Craven District Council

Jerry Croft, Skipton

Road Safety Risk Assessment

Report Ref:	8376/AND/001/01	January 2015	
Author:	Adam Darwin		
Checked & Approved:	David Colley	Date:	12 January 2015

Drawing 8376/001 Problem Location Plan

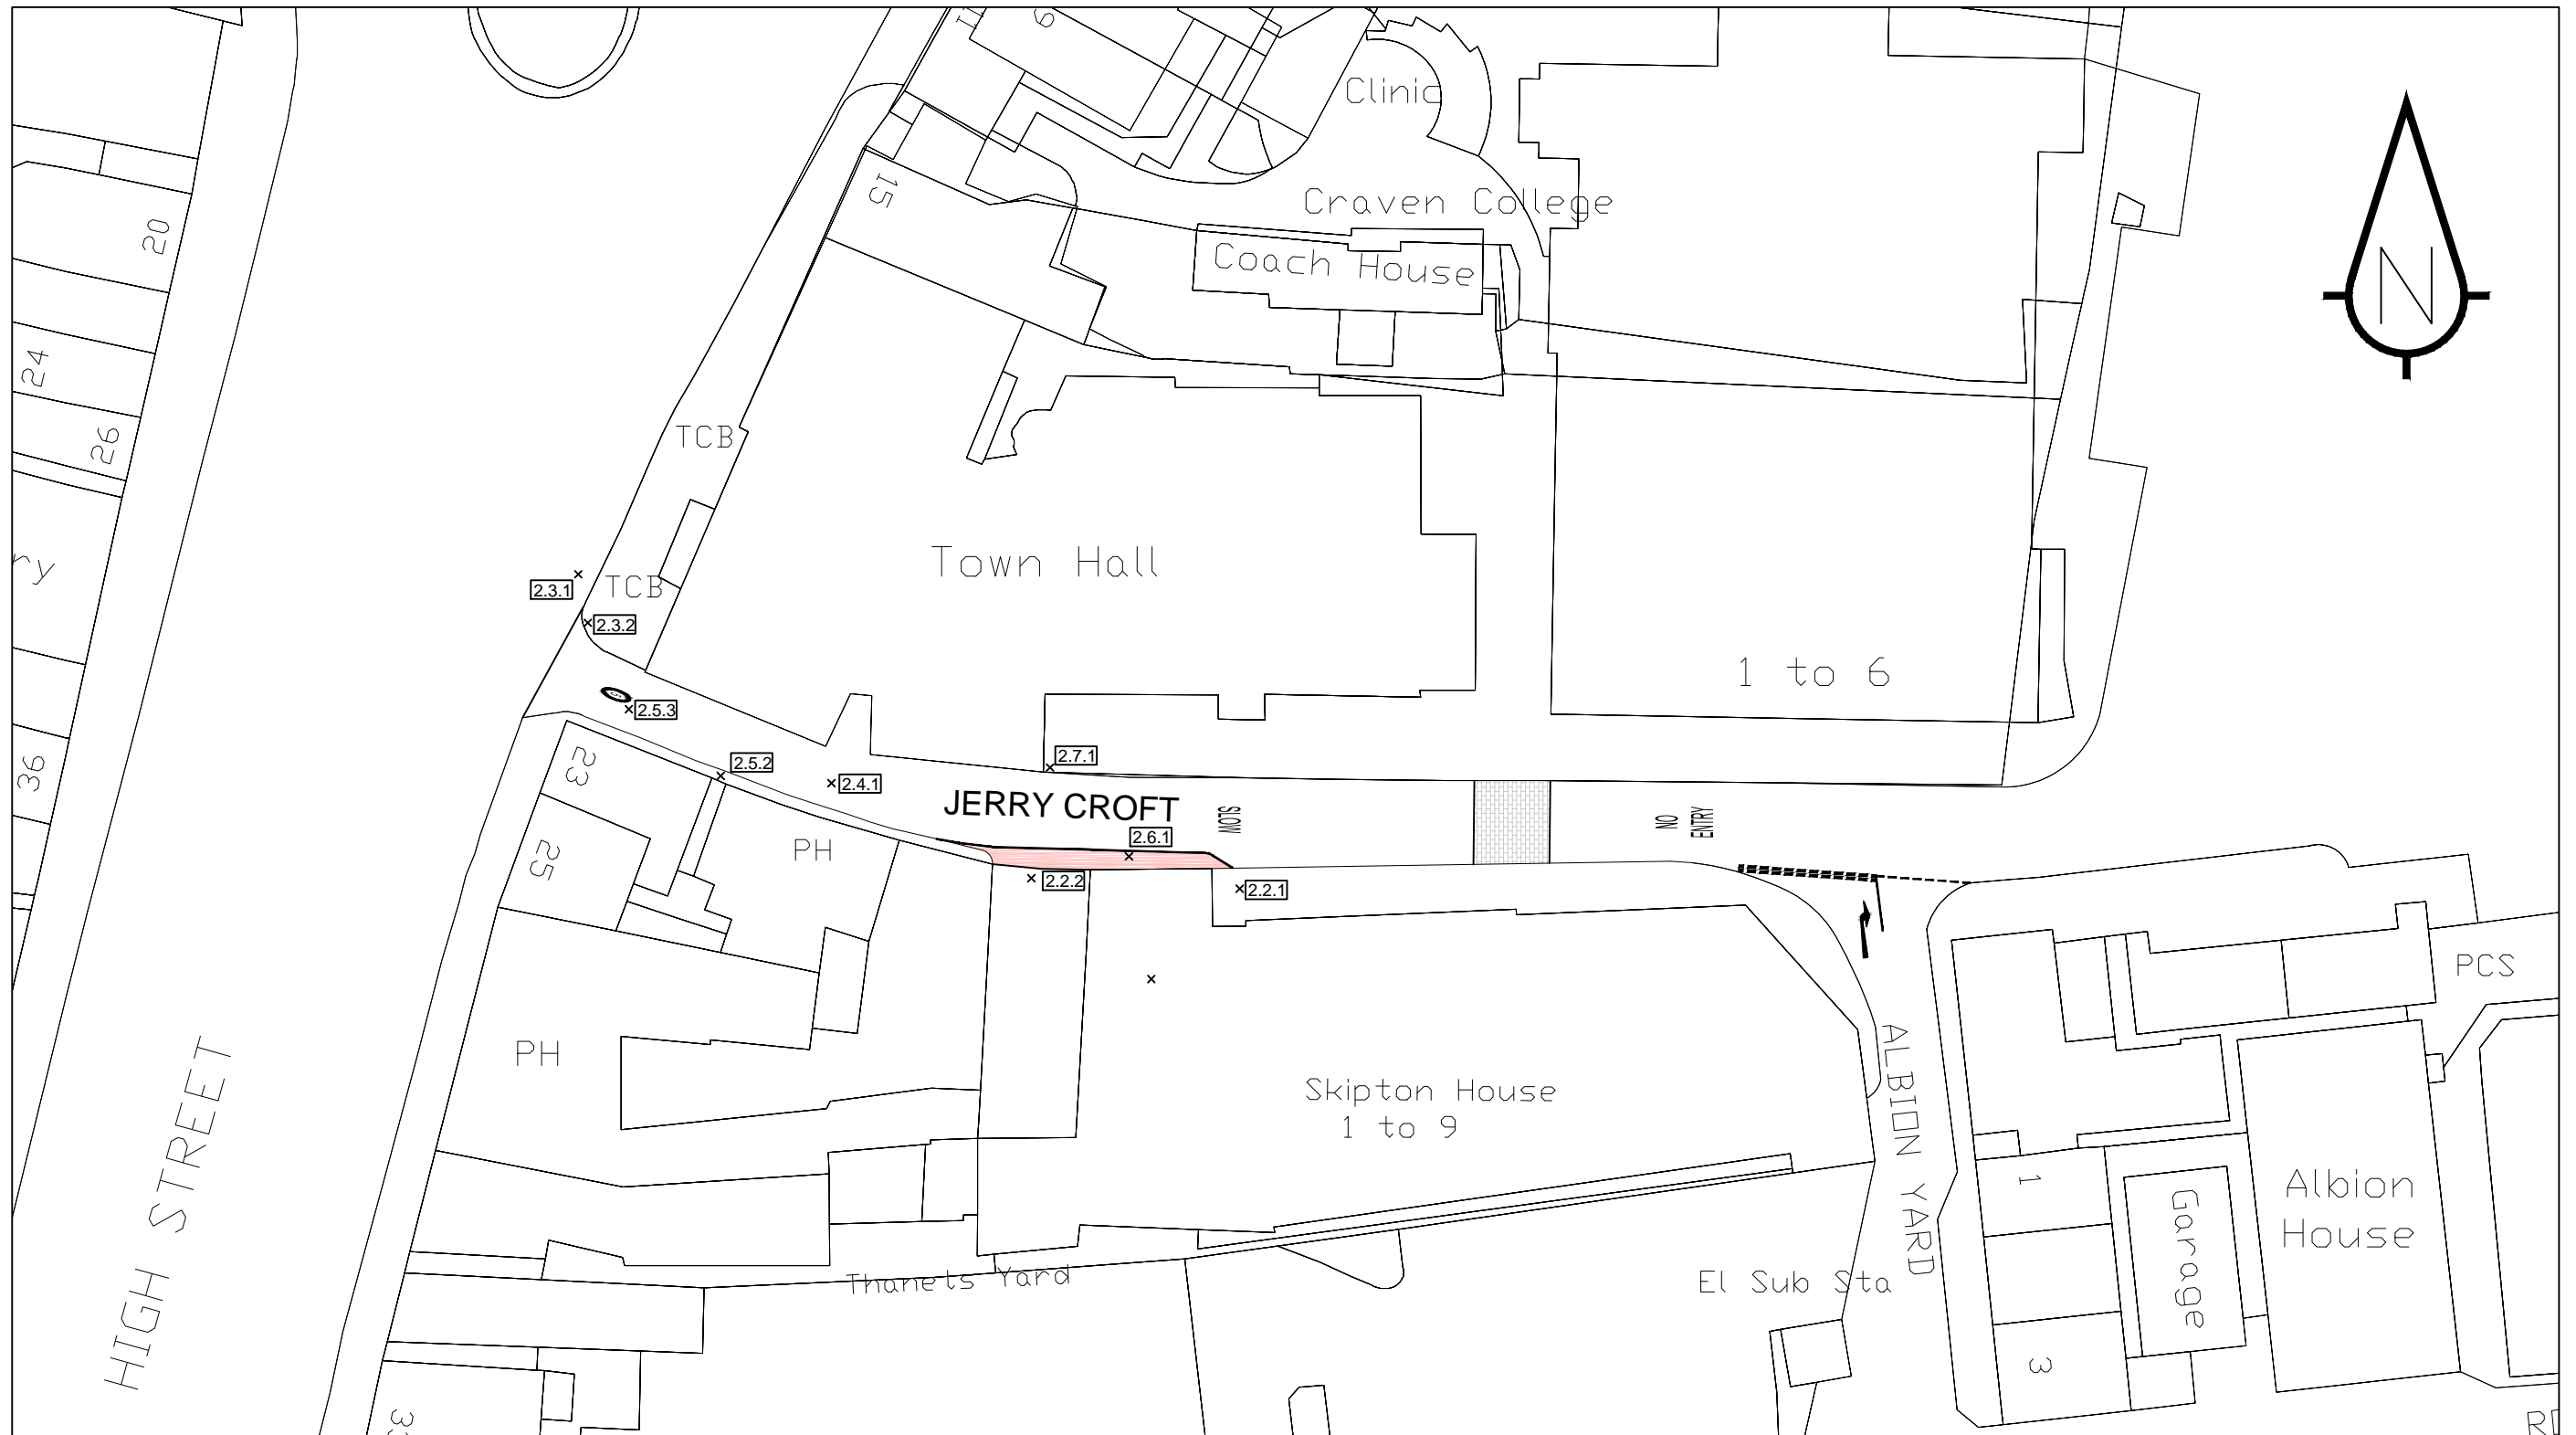
- 2.1.6 The following sections identify some of the key safety problems that have been identified, with drawing 8376/001 included in **Appendix A** identifying their approximate location. It is noted that general problems or those with multiple locations have not all been shown.

- 2.2.1 **Problem:** A loading dock exists to serve the M&S unit from an on-street loading bay on the south side of Jerry Croft. The loading bay was observed being used by a large articulated HGV, which was required to reverse into position at the loading dock. The waiting vehicle then blocked the pedestrian route. The reversing manoeuvre creates a hazard for all traffic, but particularly for pedestrians and other less conspicuous road users such as cyclists. The waiting vehicle also forces pedestrians to leave the footway and walk within the carriageway in conflict with vehicular traffic.

2.2.2 **Problem:** Jerry Croft provides access to the service yard for the Red Lion Public House (and other adjacent businesses). During the site visit, beer deliveries took place that involved a large rigid bodied HGV waiting in the M&S loading bay and barrels being manually handling between here and the public house. As an M&S delivery vehicle arrived during the beer delivery, the brewery vehicle needed to move out of the loading bay towards the Albion Yard junction and then unload from this point, which increased the carry distance to over 50m.

2.3.1 **Problem:** During market days loading takes place on High Street. During the site visit a service vehicle was observed loading immediately north of the Jerry Croft junction. This resulted in visibility being restricted for drivers turning left into Jerry Croft, which could result in drivers being unable to brake in time to stop for

- 2.3.2 **Problem:** Immediately north of the Jerry Croft junction on High Street are a number of flower planters, other street furniture and a Christmas tree, which also restricted visibility between left turning vehicles into Jerry Croft and pedestrians crossing the junction (as 2.3.1). The height of the planters restricts visibility for shorter pedestrians, who would be at greater risk of collisions.

- 2.3.3 **Problem:** Right turns from High Street in to Jerry Croft are not permitted. However, the directional signage and road markings that confirm this are not particularly conspicuous. This is likely to result in drivers failing to observe the no right turn restrictions and turning right into Jerry Croft. On market days the market stalls on the south side of the junction restrict visibility, creating similar problems to those identified in 2.3.1 - 2.3.2.

- 2.4.1 **Problem:** Both the carriageway and footway (where provided) on Jerry Croft are narrow, being a total of approximately 5m wide close to the junction with High Street. Whilst there aren't rigid standards on the carriageway widths required in this specific situation, a minimum desirable width may be closer to 5.7m (this would allow a 1.5m footway, 3.7m wide carriageway and 0.5m clearance from northern building line). The narrow footway, which is less than 1.5m wide requires passing pedestrians to walk into the carriageway. The narrow carriageway requires large vehicles such as delivery vehicles and coaches that are permitted to use Jerry Croft to encroach the footway when turning into Jerry Croft from High Street. Both

2.5.1 Problem: Jerry Croft does not include continuous pedestrian links of adequate width for two-way pedestrian flow along its full length. This includes sections of the road that do not include a segregated footway. Instead a marked pedestrian route is provided within the carriageway, adjacent to the Red Lion service yard. Along the full length of Jerry Croft all footways and pedestrianised areas include low height kerbs. Both of these factors encourage pedestrians to utilise the full width of the carriageway as a shared space with vehicles. However, this situation is not obvious to all drivers who treat the carriageway as a space where vehicles have priority, which results pedestrian/vehicle conflicts, particularly with pedestrians stepping off the pedestrian areas into the path of vehicles. Some warning signage is provided to highlight the presence on pedestrians within the carriageway. However, this is close to the exit of the one-way section and is therefore ineffective.

2.5.2 Problem: A number of pedestrian accesses to buildings exist on the south side of Jerry Croft. As pedestrians exiting these buildings do so directly onto the footway, with restricted intervisibility and where the footway is narrow, there is potential for exiting pedestrians to collide with passing pedestrians, or walk into the path of vehicles, particularly large vehicles that may be overhanging the footway as outlined in paragraph 2.4.1.

2.5.3 Problem: Immediately upon entry to Jerry Croft, a 5mph roundel road marking is provided to encourage slow vehicle speeds. However, this appears to be relatively ineffective, with virtually all drivers travelling in excess of 5mph. As pedestrians are likely to be present within the carriageway, as identified paragraph 2.5.1, any pedestrian/vehicle collisions that occur may be at higher speeds, which are likely to be of greater severity. As Jerry Croft has a left hand bend upon entry from High Street, forward visibility is restricted by the adjacent building, which increases the potential for vehicles colliding with pedestrians, particularly those walking in the carriageway on the north side of Jerry Croft.

2.6.1 Problem: A number of trip hazards exist on Jerry Croft. These include the dropped kerbs adjacent to the pedestrianised areas, gully grates that are not of pedestrian friendly design and drainage channels. Of particular note is the drainage channel located across the Red Lion public house yard, which tapers across the width of the marked on-street pedestrian route.

2.7.1 **Problem:** Street lighting is provided on Jerry Croft. However, the provision appears to be minimal (single column located near Albion Yard junction), which may result in poor lighting conditions along sections of the road (although the site visit was undertaken in daylight hours, so the street lighting was not observed in operation). The lack of adequate lighting can exacerbate a number of safety problems and in particular would increase the potential for pedestrian/vehicle conflict. It is noted that a street lighting column that was previously provided on Jerry Croft, has been removed as part of the current works at the Town Hall.

Recommendation: Alterations to the pedestrian route along Jerry Croft should be considered. This may include an improved pedestrian route on the south side from High Street up to the M&S loading bay. Pedestrians could then be transferred at this point to a footway on the north side, reducing conflict with these delivery vehicles.

Recommendation: Loading restrictions could be introduced on Jerry Croft to control it's use by service vehicles. However, the practicalities of servicing directly from the service yards should be discussed with the associated businesses to ensure that their servicing could be undertaken safely and efficiently, otherwise they may object to loading restrictions being introduced on Jerry Croft. Should it be deemed necessary to maintain some servicing directly from Jerry Croft, it may be possible to provide an appropriately located and designed loading bay closer to the junction with Albion Yard, with loading restricted in all other areas (except the M&S loading bay), which would reduce the associated risk.

Recommendation: Loading restrictions could be introduced on High Street to encourage loading in more appropriate locations.

Recommendation: Relocate planters etc. away from pedestrian crossing point, to ensure adequate pedestrian visibility is provided.

Recommendation: Provide improved warning signage and road markings on High Street.

Recommendation: As it is not possible to widen the highway, various measures could be considered to reduce this risk. Assuming the current traffic management arrangement are maintained that allow access to the car/coach park and for servicing, alterations to Jerry Croft could instead be proposed that could include improvements to footways and pedestrian crossing provision or perhaps a shared surface treatment, with associated traffic calming features. Even if it considered necessary to maintain access for servicing and for cars entering the car park, it would be beneficial to highway safety on Jerry Croft to direct coach traffic to use the alternative route to the parking area.

Recommendation: Provide improved warning signage upon entry to Jerry Croft. As para. 2.4.1, alterations to Jerry Croft could also be proposed that may include improvements to footways and pedestrian crossing provision; or a shared surface treatment with associated traffic calming features.

Recommendation: Contrasting surface treatments could be provided to highlight the building entrances. Subject to vehicle turning requirements, bollards could be provided to ensure that vehicles do not pass close to the building entrances.

Recommendation: Traffic calming measures could be provided to reduce vehicle speeds. To achieve a low vehicle speed of 5mph, it is likely that some form of vertical deflection features would be required. This could be in the form of raised plateaux's that are frequently located along Jerry Croft. Prominent signage should also be provided at the entrance to Jerry Croft from High Street.

Recommendation: Should improvement be proposed along Jerry Croft, these should include measures to remove or minimise trip hazards. The initial focus

Recommendation: Review existing street lighting provision and upgrade where necessary.
